Cree® CLR6A-TKW LED Product Change Notification

PCN Reference Number: CREE-PCN-1111

Date Issued: June 10, 2020

- The current and new appearances are shown below:

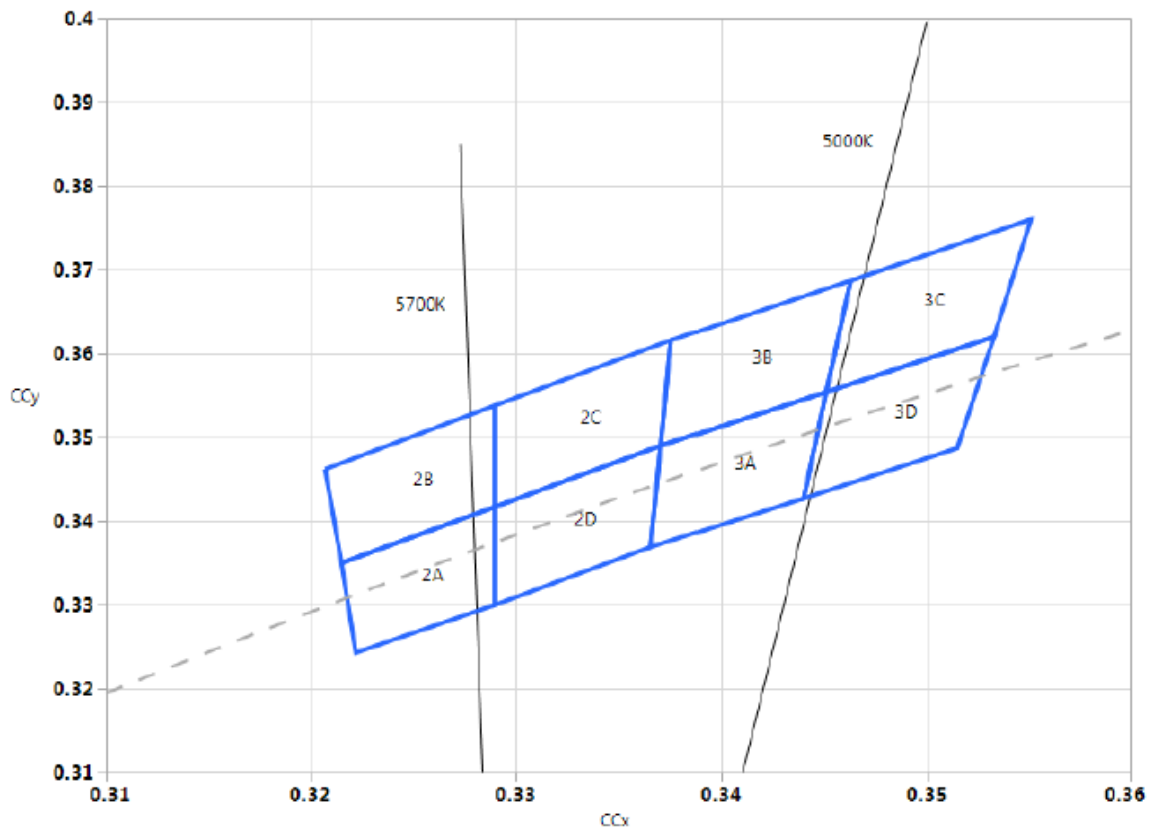
Cree is changing the red & green chip and lead frame on CLR6A-TKW LEDs. Cree is also changing the color bins from 5700 K (2A/2B/2C/2D) and 5000 K (3A/3B/3C/3D) to 5700 K (2A/2B/2C/2D/**2R/2S/2T/2U**) and 5000 K (3A/3B/3C/3D/**3R/3S/3T/3U**).

2. The current and new CIE chromaticity diagrams are shown below:
 Current:

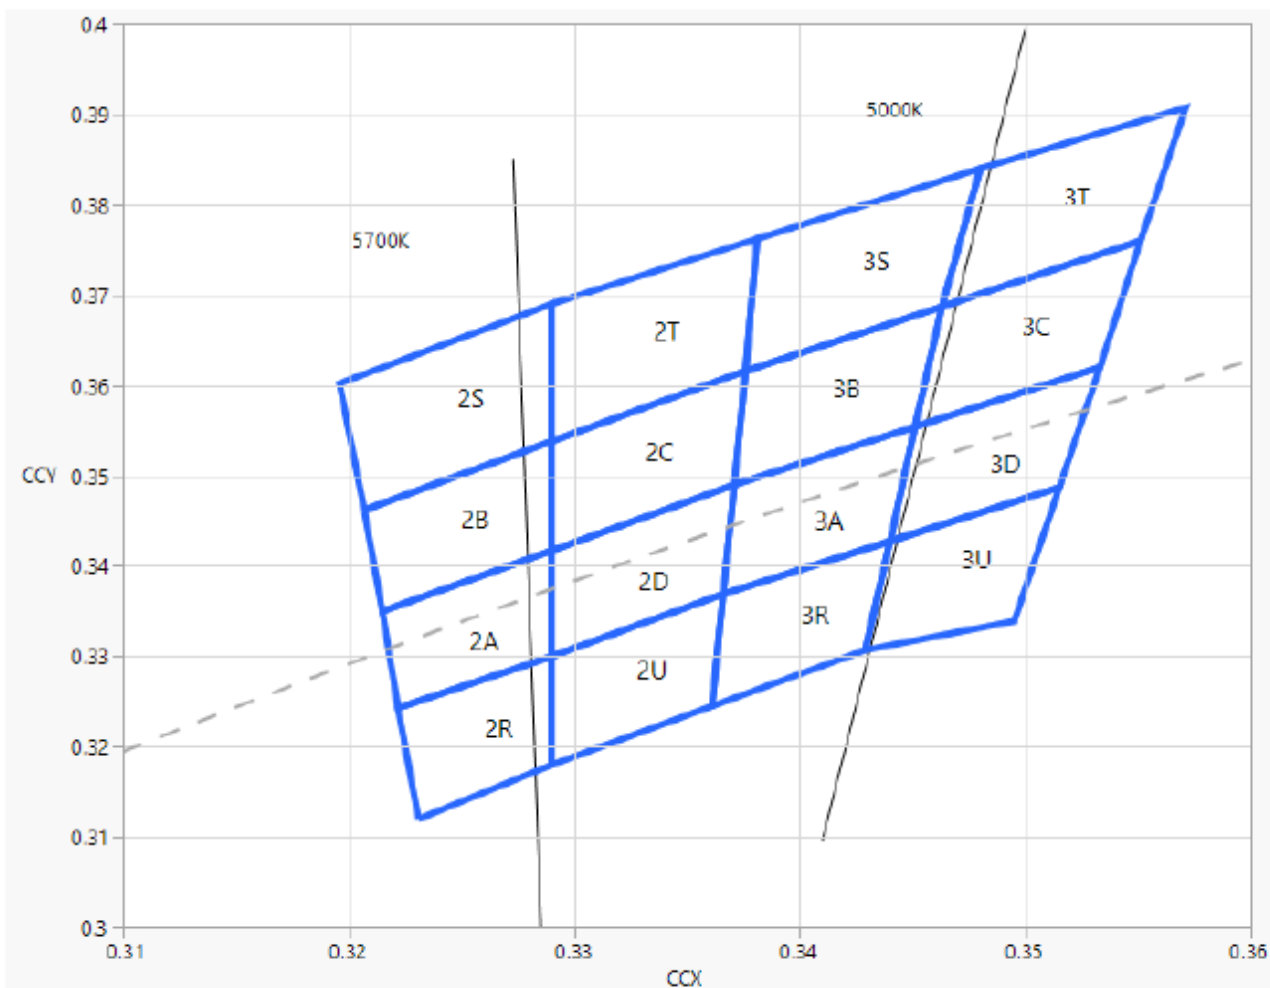
The specification of the above product has changed. The color binning and order code information have changed.
